ISSUE: Certificate of Appropriateness for alterations and signage.

APPLICANT: Bloom Tea

LOCATION: Old and Historic Alexandria District
425 South Washington Street

BAR#2023-00229
425 S Washington Street

Figure 4 - Cornice detail

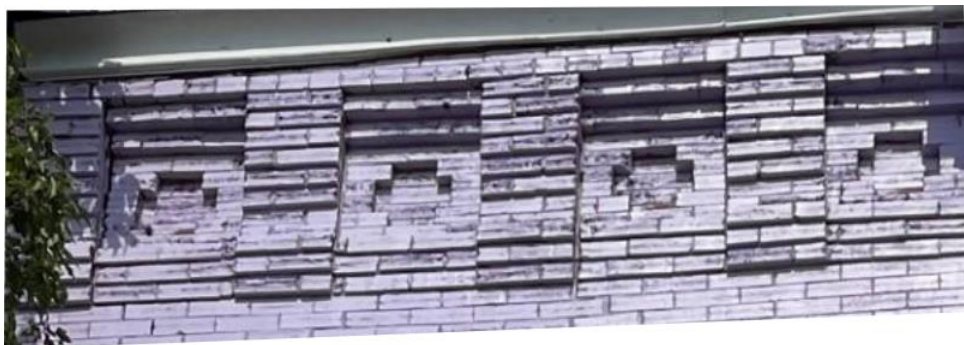
Staff finds that painting previously unpainted masonry on an **Early** Buildings is not appropriate since it will cause the deterioration of the brick masonry. Furthermore, the paint obscures significant architectural features (Figures 4 & 5) which were meant to be unpainted. Therefore, staff recommends denial of the after-the-fact work of painting a previously unpainted masonry and recommends that the applicant remove the paint as soon as possible to avoid future damage.
